| PROJECT        | Our Town Hall                       |
| DRAWING TITLE  | Chimney Number CS22 proposed repair |
| DRAWING STATUS | S4 - Construction                   |

OTH-PUR-TH-RF-DWG-A-4182 03

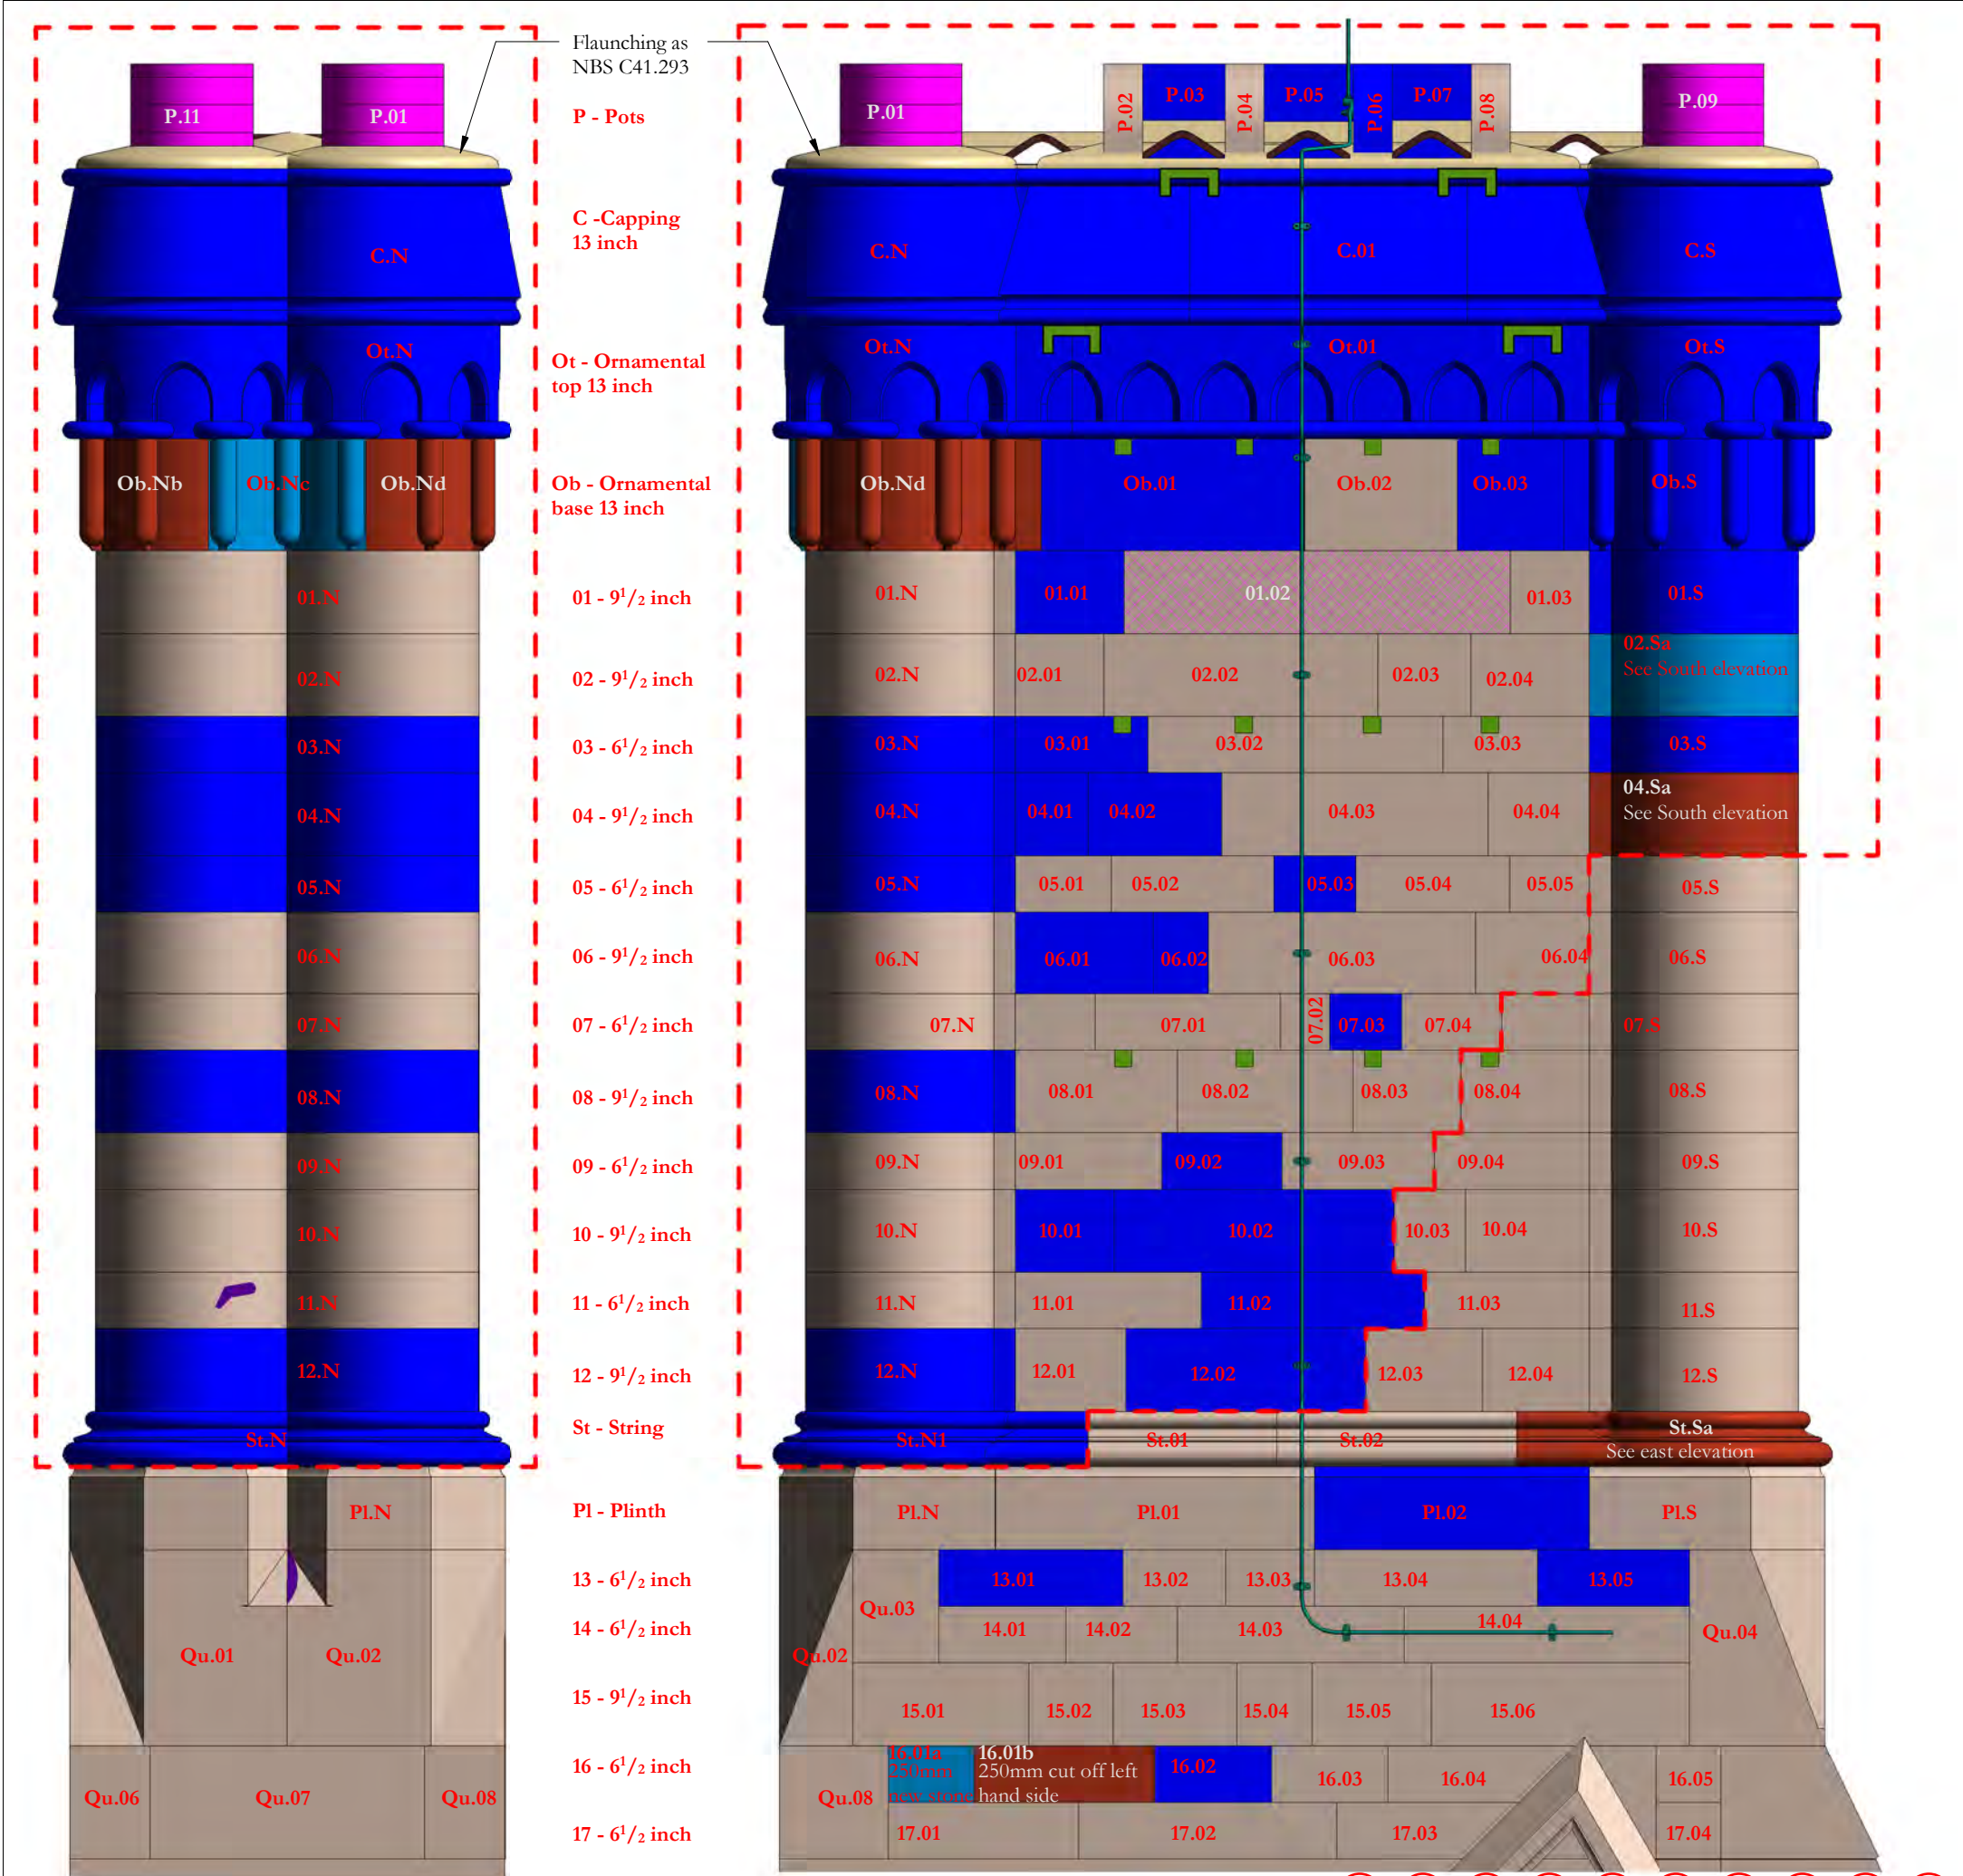
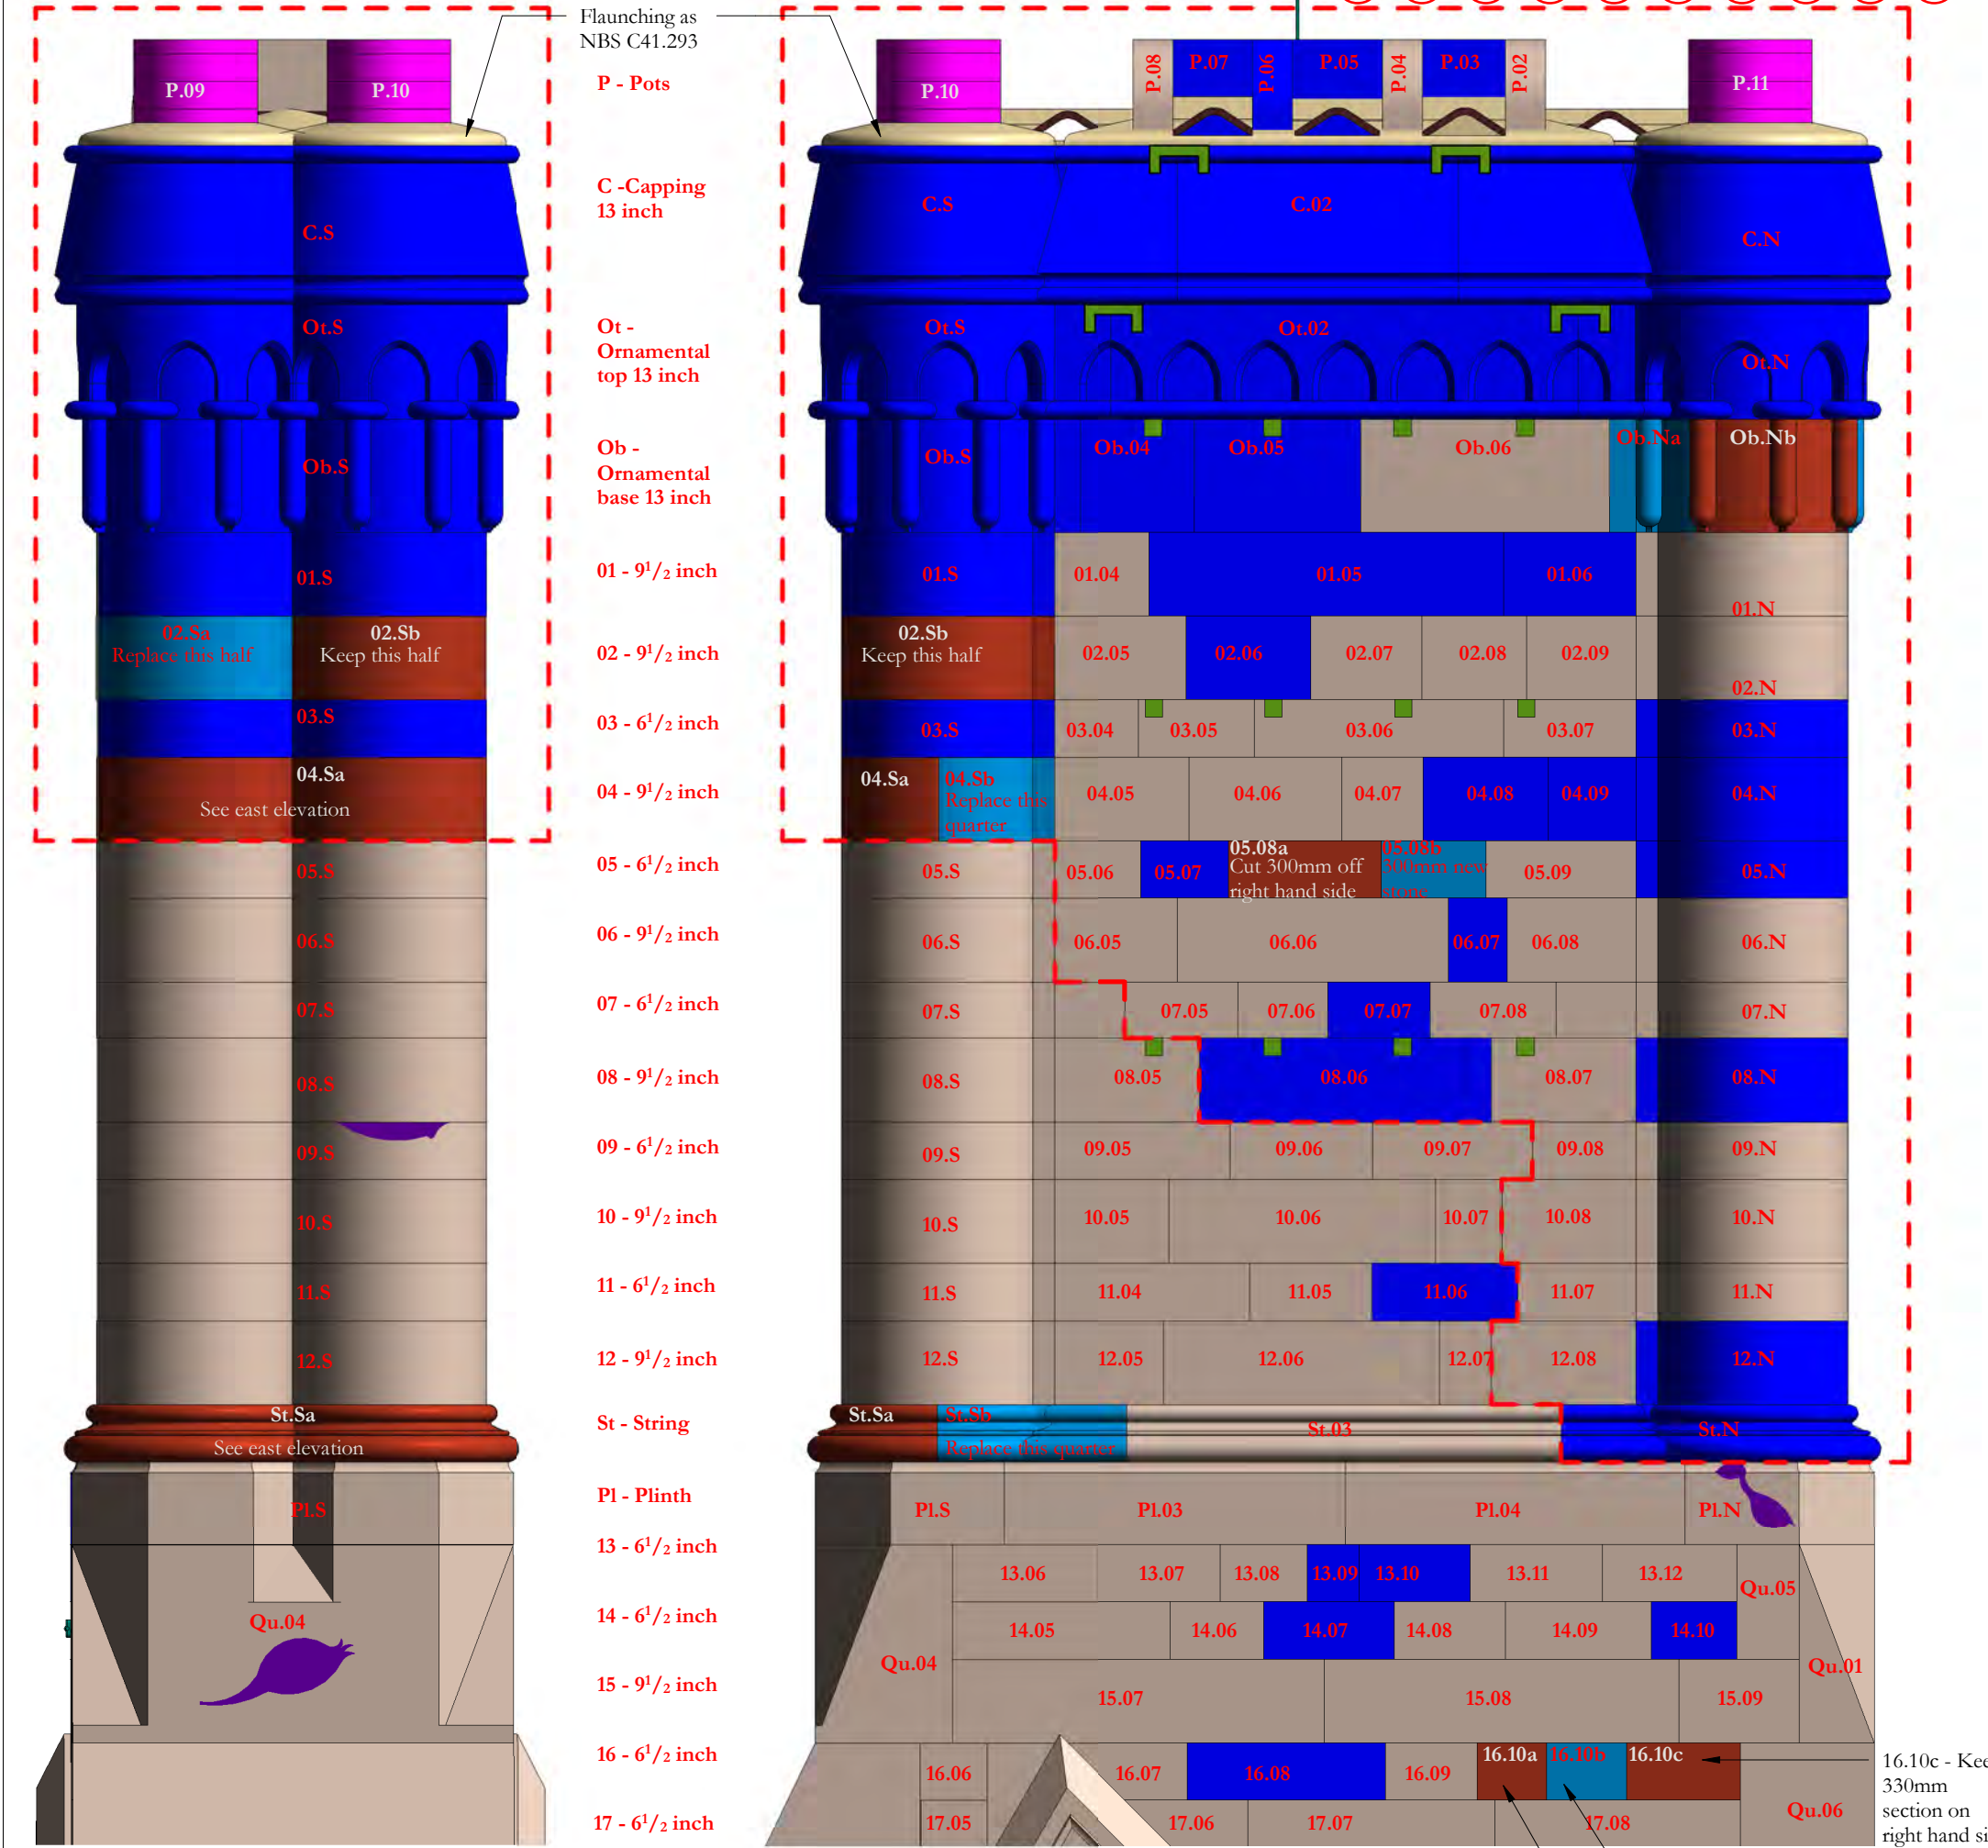
Revision 02  
Dismantling line amended to correspond to actual extent of work carried out.  
Cross feather cramps added to top of courses Ob, 03 and 08

Revision 01  
Drawing updated post validation survey
